Contract #: 04-0120F4Cty: SF/ALA Rte: 80 PM: 13.2/13.9File #: 69.25B**QUALITY ASSURANCE -- NON-CONFORMANCE REPORT****Location:** Changxing Island, Shanghai, P.R. China**Report No:** NCR-000233**Prime Contractor:** American Bridge/Fluor Enterprises, a JV**Date:** 13-Mar-2009**Submitting Contractor:** Zhenhua Port Machinery Company, Ltd (ZPMC), Changxing Island**NCR #:** ZPMC-0208**Type of problem:****Welding****Concrete****Other****Welding****Curing****Procedural****Bridge No:** 34-0006**Joint fit-up****Coating****Other****Component:** OBG Segment 4BE Side Plates SP32A & SP24A**Procedural****Procedural****Description:****Reference Description:** Perform of Heat Straightening without approved procedures**Description of Non-Conformance:**

Subject: NCR No. ZPMC-0208

Reference Description: Perform of Heat Straightening without approved procedures

简图 Sketch

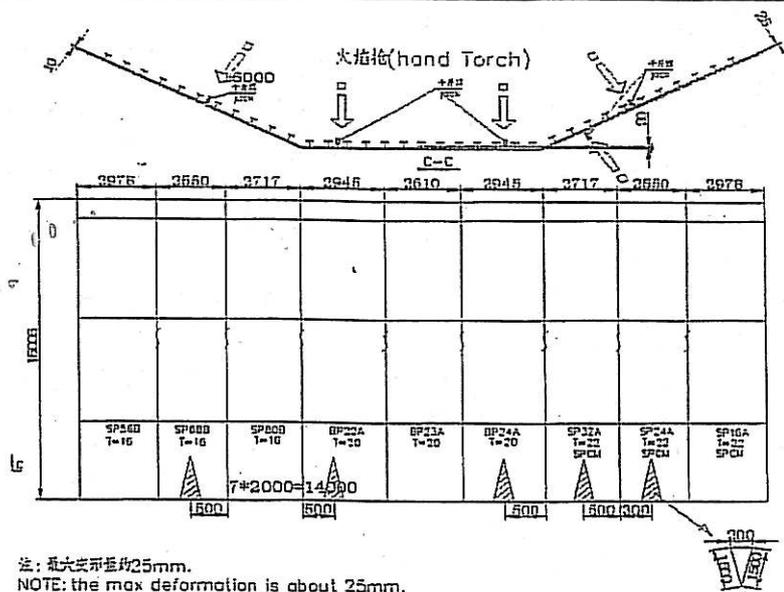
On Jan. 08, 2009, CT measured a maximum deflection on the distorted side panel of 45mm over the edge span of approximately 4700mm. For the 16mm thick side plate, the Special Provisions require Engineer approval for distortions over 6 in 1000. The distortion of this plate is 10 in 1000. ZPMC performed the heat straightening by the use of a torch, hydraulic jack and chain fall attached to a counter weight.

Jacking shall not be used to plastically deform the component. The jack will only be used as a fixture. After finishing heat straightening operation, all welds in the heated areas shall have MT performed. Provide notification to CT prior to performing MT inspection after heat straightening.

实施次数(Number of application): 1~3

最高温度(Maximum temperature): <600°C
